### **Response for Review of Biomass Energy Plant-Lumut (0249)**

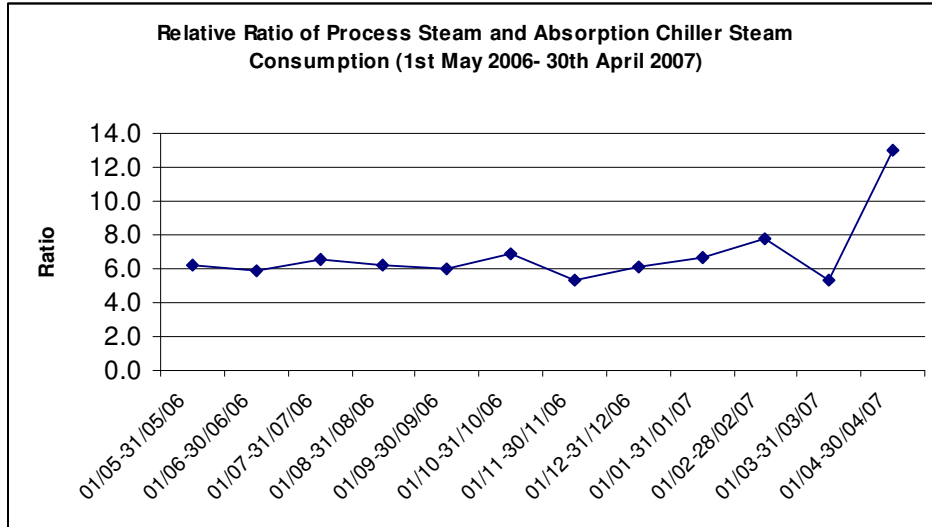
2. The PDD stated that 15 t/h of steam will be generated for palm oil refinery process consumption and 3 t/h will be used to provide cooling through a new absorption chiller system.. However, the relative steam supply to the chiller during this monitoring period is below the relative steam supply to the refinery. Further clarification is needed.

However the average absorption chiller steam demand in the actual, monitored operation has been lower than 2.5 t/hr. Relatively the average steam demand for the refinery is also lower than the projected demand in the PDD of 15 t/hr. The relative ratio between process steam and absorption chiller steam is approximately 6.0. The graph below indicates the fluctuation of the relative ratio for the period covered by second monitoring and verification report.

The steam demand for both the process and absorption chiller is very much depending on the palm oil crop season, scheduled plant shutdown periods and efficiency of the heat exchangers. The relative ratio between process steam and absorption chiller steam consumption is not constant but approximate to the calculated value of 6.0.

Note: The absorption chiller was not in operation for maintenance for approximately 2 weeks in the month of April 2007 which causes the relative ratio to shoot up to 13.
